DONALD C. COOK NUCLEAR PLANT
SAFETY SYSTEM FUNCTIONAL INSPECTION
Auxiliary Feedwater System

October 5, 1987

DONALD C. COOK NUCLEAR PLANT
SAFETY SYSTEM FUNCTIONAL INSPECTION

SKETCH 1
CONDENSATE STORAGE TANK
ERROR BAND BETWEEN LOW-LOW TANK LEVEL AND MIN. NPSH

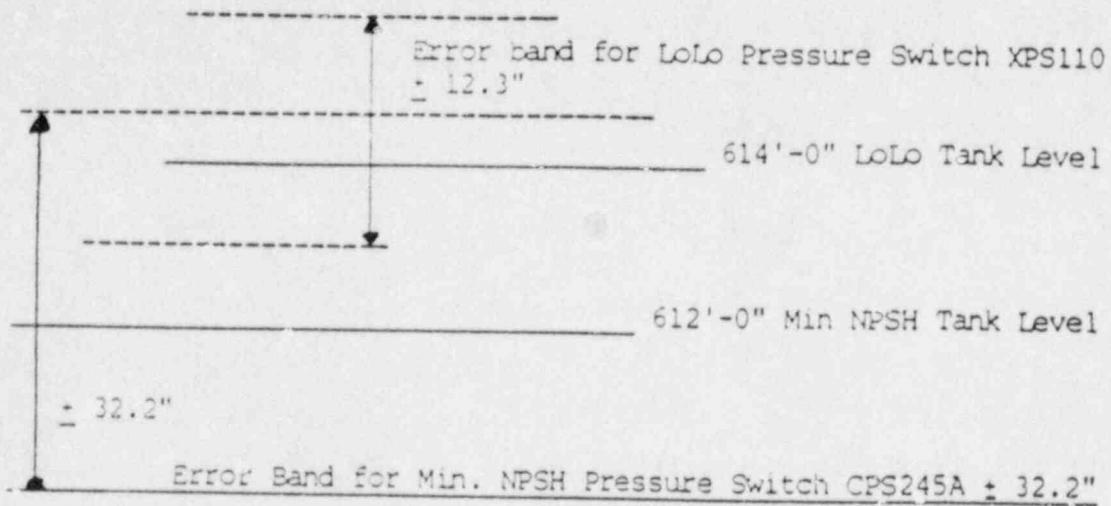
If the minimum NPSH activates at 609'-3.8", the 3 auxiliary feed pumps could run dry and be damaged. They would not be available to provide auxiliary feed water.

SKETCH 1
CONDENSATE STORAGE TANK
LEVEL MONITORING

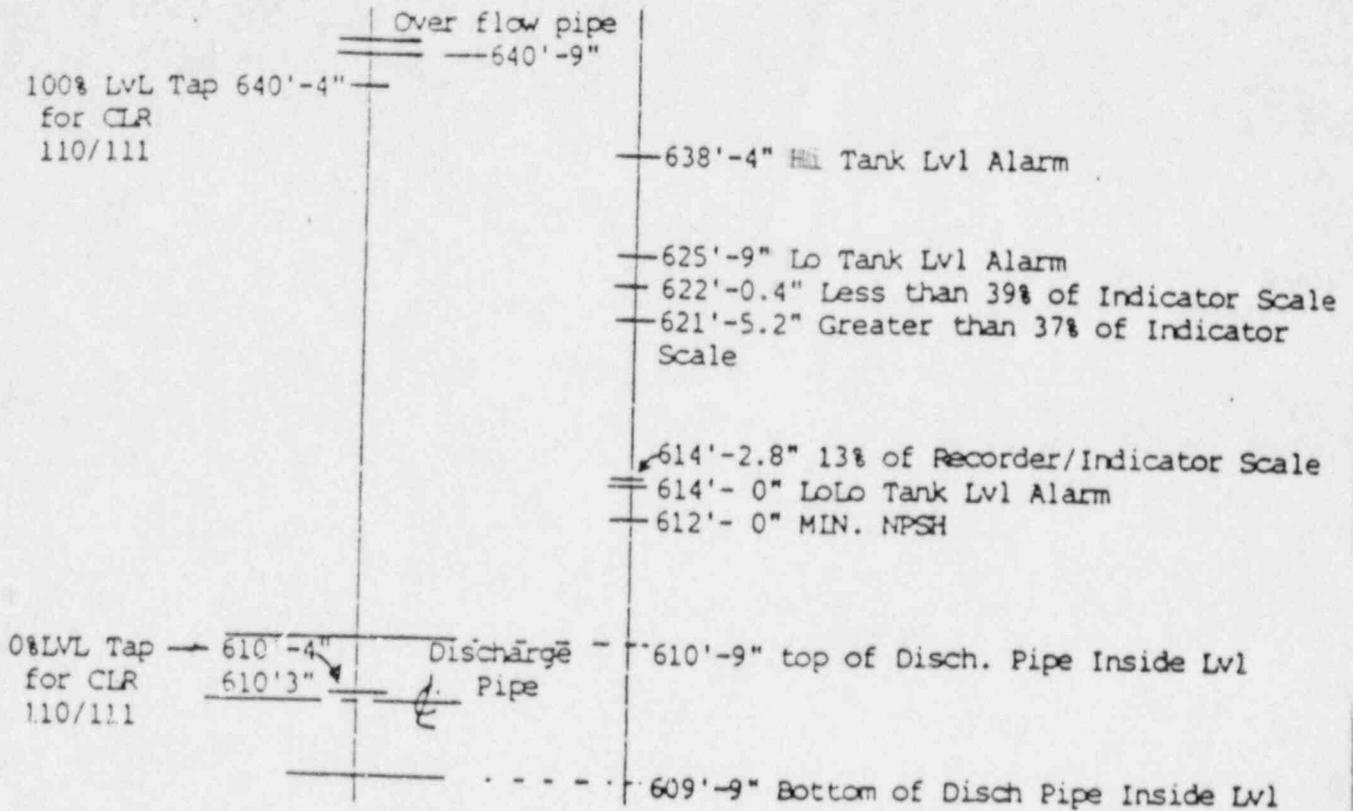
The CST does not hold 175,000 gallons of water at hot shutdown conditions above the requirement for 20 minutes available following the Lo Lo Level alarm. There is only 131,440 gallons. This is a violation of the tech specs as they are written. Ambiguous and inconsistent information is presented to the operator in his procedures, on the actual alarm points and control board indications. Calculation TH-87-03 (dated 5/12/87) indicates the minimum requirement for water is less

than 175,000 gallons of water to ensure 9 hours supply of water for the CST at hot shutdown conditions. The requirements of the CST Level should be reviewed and revised. All documents related to the CST Level should be changed to agree with the actual needs.

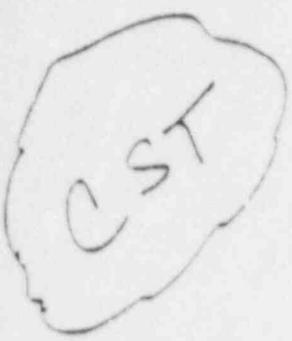
Concern 4.1: The NPSH Switch (AFW Pump Low Suction Pressure Switch) may not alarm until the water level falls to 609' 3.8", potentially causing the pump to run dry without the operator knowing it.

Response: Our error analysis indicates at a maximum error on the AFW Low Suction Pressure alarm the level would still be above the top of the CST's outlet pipe. This error represents only 0.3 psig lower pressure at the AFW pump inlet. In view of this minimal pressure difference and the fact that the CST outlet pipe is not uncovered the present alarm setting provides adequate pump protection.

Due to above evaluation it was concluded that no physical corrective action was necessary and that no safety significance is evident.
